***3 Volt Intel[®] Advanced Boot
Block Flash Memory
28F004/400/008/800/
016/160/320/640B3 (x8/x16)***

Specification Update

April 2002

Order Number: 297948-012

2. Invalid Read Durations for CE# High Pulse Width

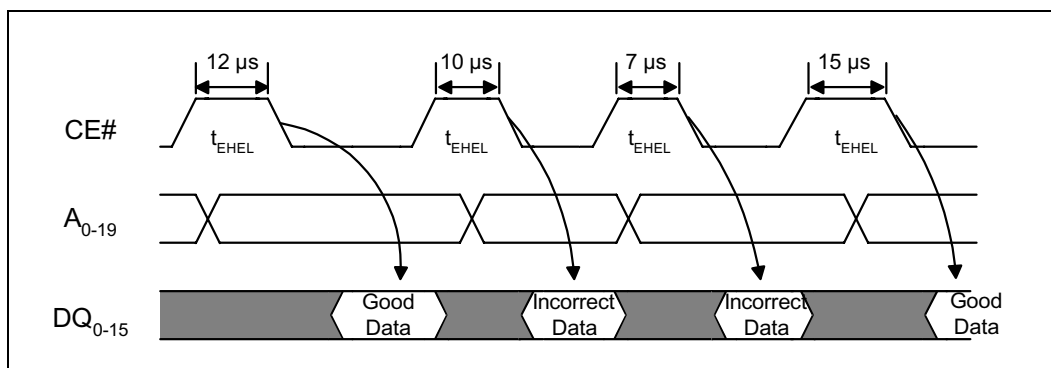
Problem: During consecutive read operations, CE# may be left low or toggled as desired. If CE# is toggled high (see diagram below) for 4 μ s–11 μ s between read operations, subsequent reads will return incorrect data.

Implication: If CE# is not toggled between consecutive reads, there is no impact. Any application that toggles CE# between read operations will be affected if the CE# high pulse width is within the nonfunctional range, i.e., 4 μ s $\leq$ t_{EH} $\leq$ 11 μ s.

Workaround: Either of the following actions will prevent this erratum:

1. Do not toggle CE# between consecutive read operations
2. Insure t_{EH} is less than 4 ms or greater than 11 μ s

5. Maximum I_{CCD} Change

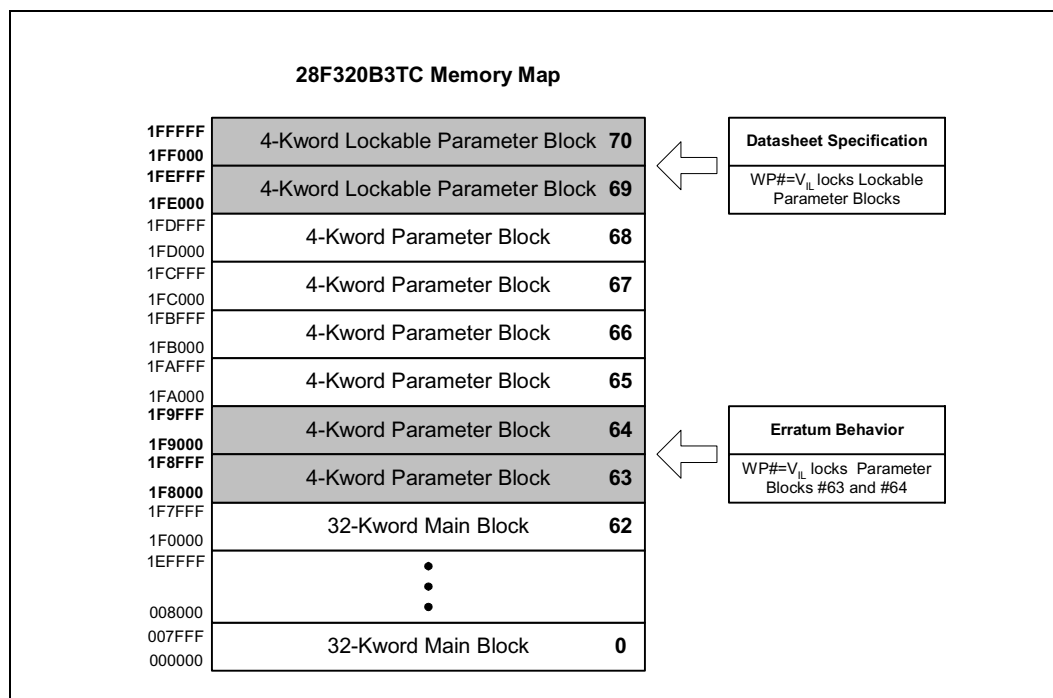
Problem: The maximum I_{CCD} increases from 20 μ A to 25 μ A. The following in the revised I_{CCD} specification:

Sym	Parameter	V _{CC}	2.7 V–3.6 V		2.7 V–2.85 V		2.7 V–3.3 V		Unit	Test Conditions
		V _{CCQ}	2.7 V–3.6 V		1.65 V–2.5 V		1.8 V–2.5 V			
		Note	Typ	Max	Typ	Max	Typ	Max		
I _{CCD}	V _{CC} Power-Down Current	6	7	25	7	25	7	25	μA	V _{CC} = V _{CC} Max V _{CCQ} = V _{CCQ} Max V _{IN} = V _{CCQ} or GND RP# = GND ± 0.2 V

Implication: The maximum I_{CCD} is specified under worst case conditions only ($V_{CC} = 3.6$ V, temperature = +85 °C). The typical I_{CCD} specification should be used to determine I_{CCD} current draw under typical conditions ($V_{CC} = 3.3$ V, temperature = +25 °C). The typical I_{CCD} specification has not changed.

7. 28F320B3xC Reset Failure

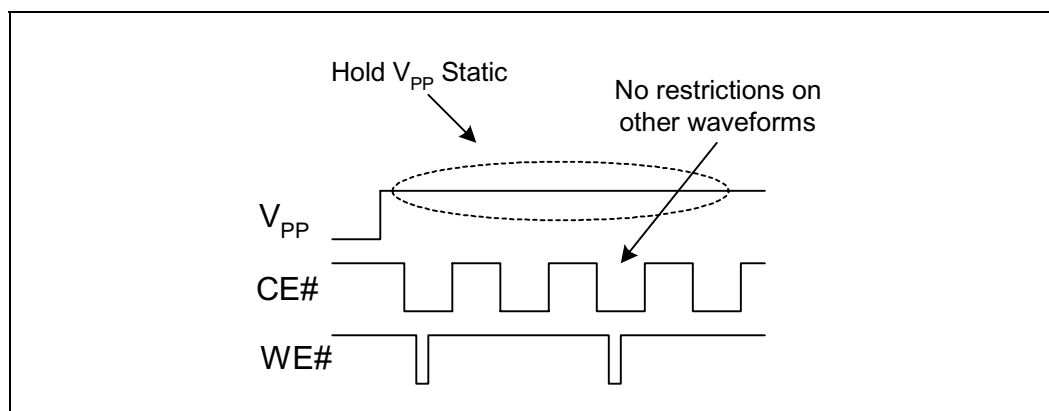
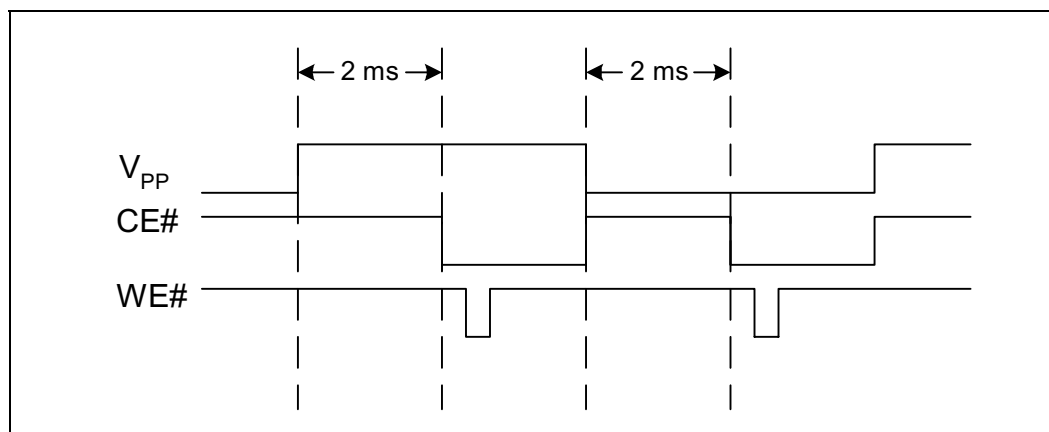
Problem: The 0.18 μ m 28F320B3xC devices can unintentionally reset under certain conditions where V_{PP} toggles.

Implication: When the reset occurs, any command being executed is interrupted and the flash switches to read array mode.

Workaround: There are four workarounds for this erratum:

1) Tie V_{PP} to V_{CC}

2) If the third and forth digits on the top side FPO mark (third line) are equal or greater than “23”, then V_{CC} may be set from 2.7 V to 3.3 V. V_{CC} must not exceed 3.3 V.

3) Set V_{PP} to a static high or static low level as shown here; and

4) Wait 2 ms after a V_{PP} transition to access the flash device as shown here.

Figure 1. Workaround Placement

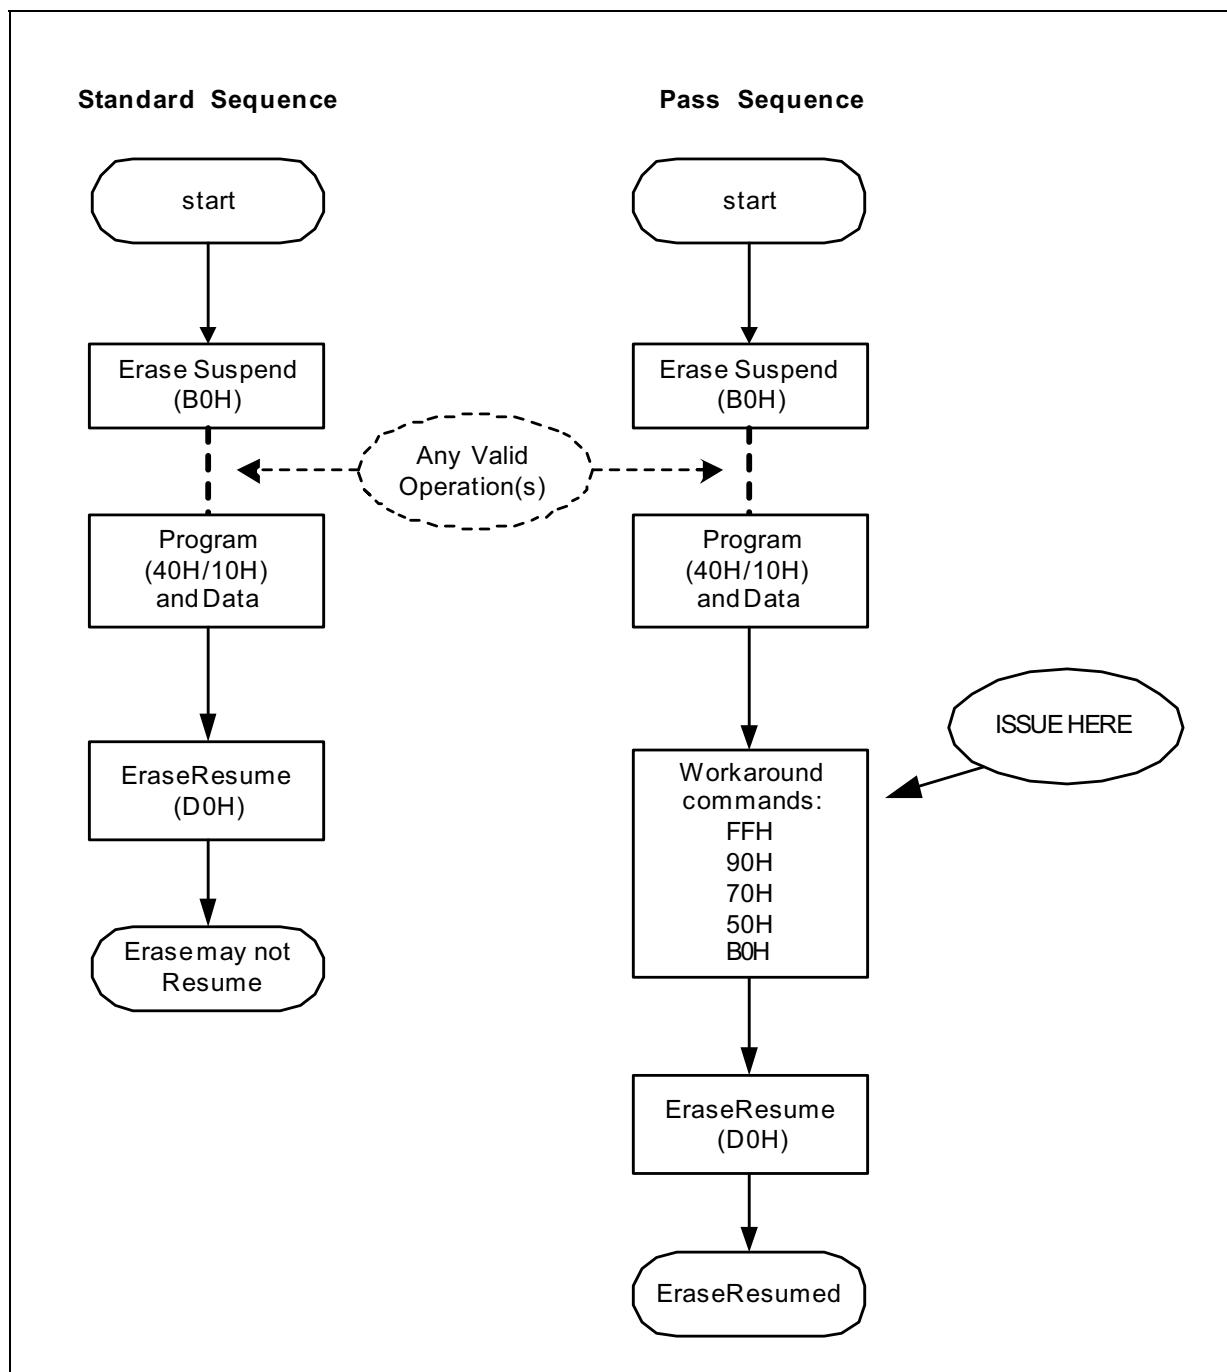
Problem: On the 0.18 μ m 28F160B3xC device, a design anomaly was discovered. During an Erase-Suspend operation, if the Program (40H/10H) sequence is executed, under limited conditions the proceeding Erase Resume command (D0H) may not actually resume the device. No customers have reported failures in product applications. Customers who use any version of FDI (Intel Flash Data Integrator) software will not see this issue. If the Read Array command is issued prior to the Erase Resume command, users will not see the issue (typical in XIP applications).

Implication: The Resume Command (D0H) may be ignored by the device and will not correctly resume. The device will appear to remain in suspend (via status register). After a reset of the flash device the status register will clear. This failure has been recreated in a lab environment only.

Workaround: There are 2 workarounds for this erratum.

1. If FDI (Intel Flash Data Integrator) software is used, users will not see the issue.
2. During an Erase-Suspend (B0H), user must issue any of the following commands listed in Table-1 after issuing the Program (40H/10H) and data sequence but before issuing the Erase-Resume (D0H) command.
